Technical BULLETIN

SAFETY RECALL

CERTAIN 2019 SPORTSMAN 17 SS and 2020–2025 SPORTSMAN 1610 SS BOATS FACTORY MODIFICATION CAMPAIGN – FLOTATION COMPLIANCE

View after hose cover is removed

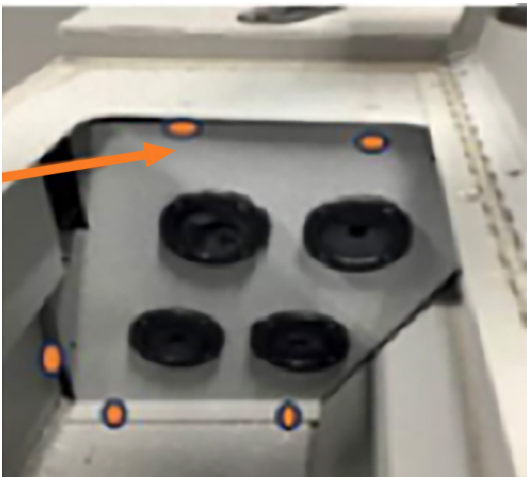
- 1) Begin by prepping the boat for foam placement.
 - a. Unscrew the (2) black screws from the rod box hose cover.

b. Discard the rod box hose cover and the black screws once removed.

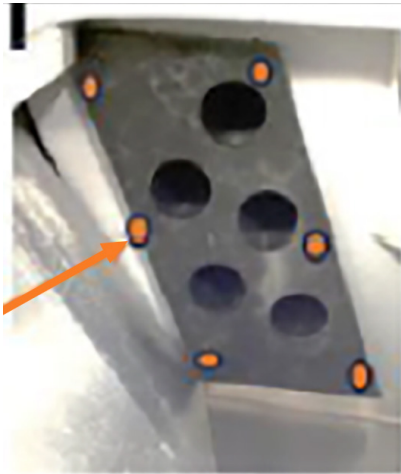
3) The new port rod holder (#73875221) is painted, with rod grommets assembled in the rod holder.

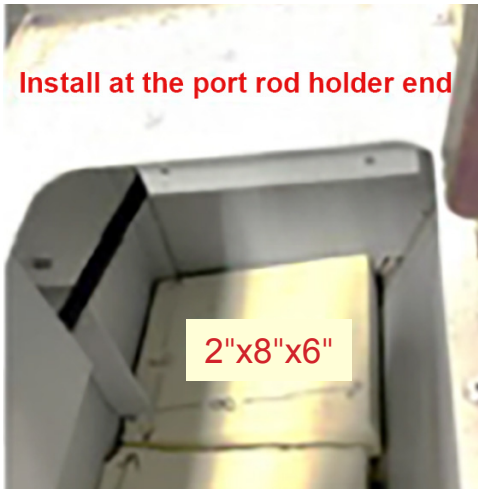
5) Insert the rod box floor foam:
a. 2 pieces of floor foam (2" x 8" x 24-3/4" - #895383)

b. 1 port rod box foam (2" x 8" x 6" - #895381)

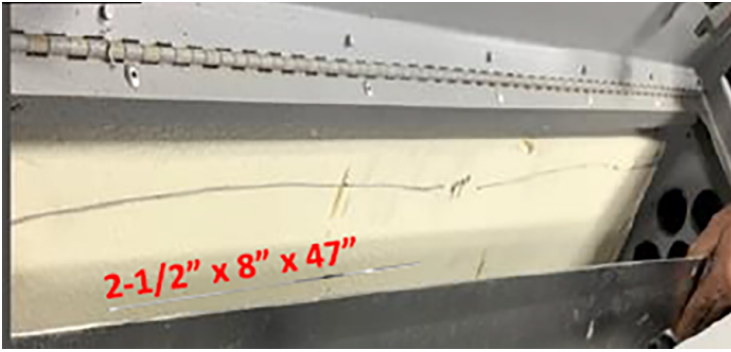
7) Insert the rod box side wall foam.

a. Install the piece of foam (2-1/2" x 8" x 47" - #895384) against the port rod box side wall.

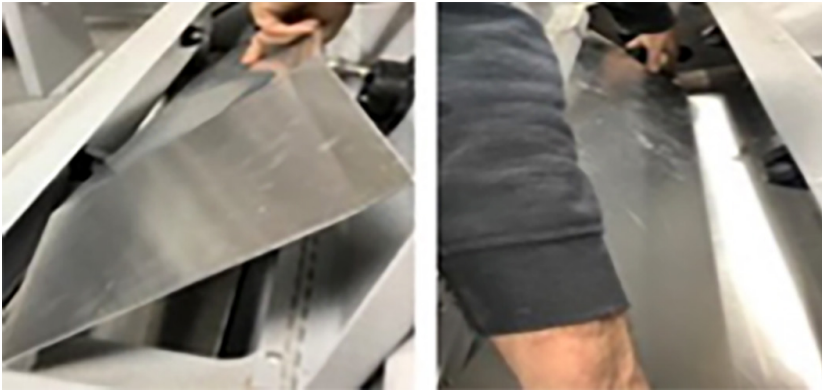
8) Insert the port rod box foam wall.

a) Install the port rod box wall (#73852711).

b) Position the foam wall in a slanted position and slide it into place.

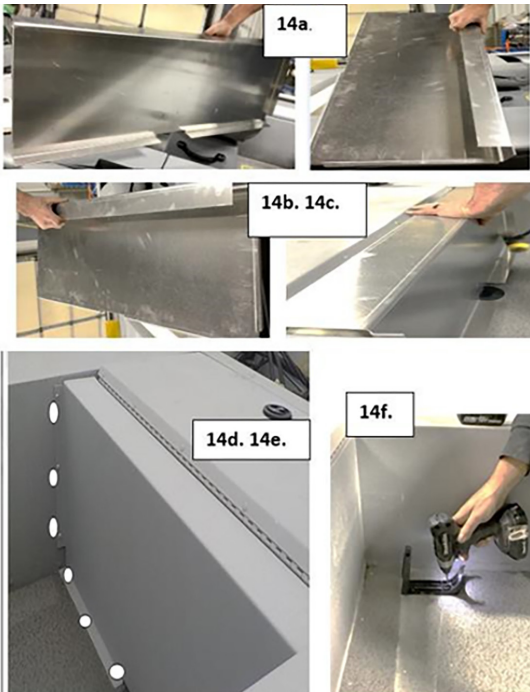
14) Install the aft bulkhead using the following instructions:

- a) Aft bulkhead (#73815087)
- b) Set the bulkhead over the top of the stacked foam.
- c) Tap the aft bulkhead firmly into place against the foam.
- d) Once the bulkhead is in place, use a #11 drill to make (3) holes onto the bulkhead side flange on both the port and starboard sides.
- e) Again, using the #11 drill, make (3) holes onto the bottom flanges on the port and starboard sides.
- f) Reinstall the fire extinguisher bracket. Make sure to set the bracket 5" from the aft bulkhead and 3" from the starboard side wall.

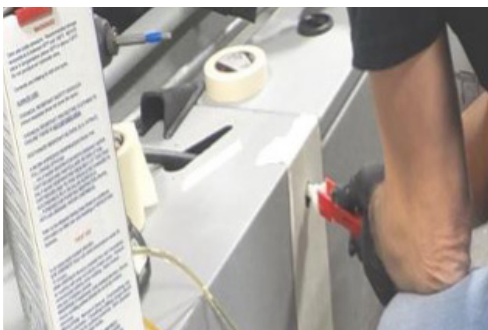
1) Inspect the front pod foam:

- Remove the cup holder at the front of the starboard side pod. First, unscrew the (4) screws and set aside.
- Drill a 1" hole.
- Visually inspect the foam for gaps or visible spaces between the foam and the boat hull. If the gap or visible space is 1/2" or more, additional foam pieces must be installed in the boat per these instructions.

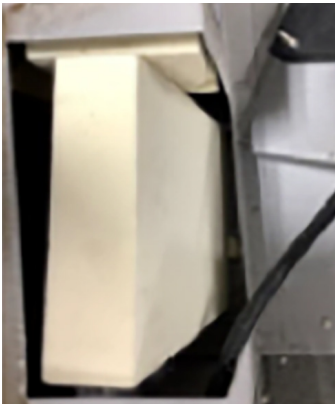
9) Install the forward port wall foam:

a. Lay the foam on the bottom (2 each—4" x 5-1/4" x 17", #895387 field fix)

b. Lay the foam on the floor of the port wall to the back (1 each—2-1/4" x 4" x 5-1/4" x 16", #895388 Sloped field fix).

c. Set the sloped piece of foam in the front on the top of the floor foam (4" x 5-1/4" x 16", #895389 field fix)

d. Set each piece of foam (2" x 10" x 11", #895390 field fix) in front of the throttle opening.
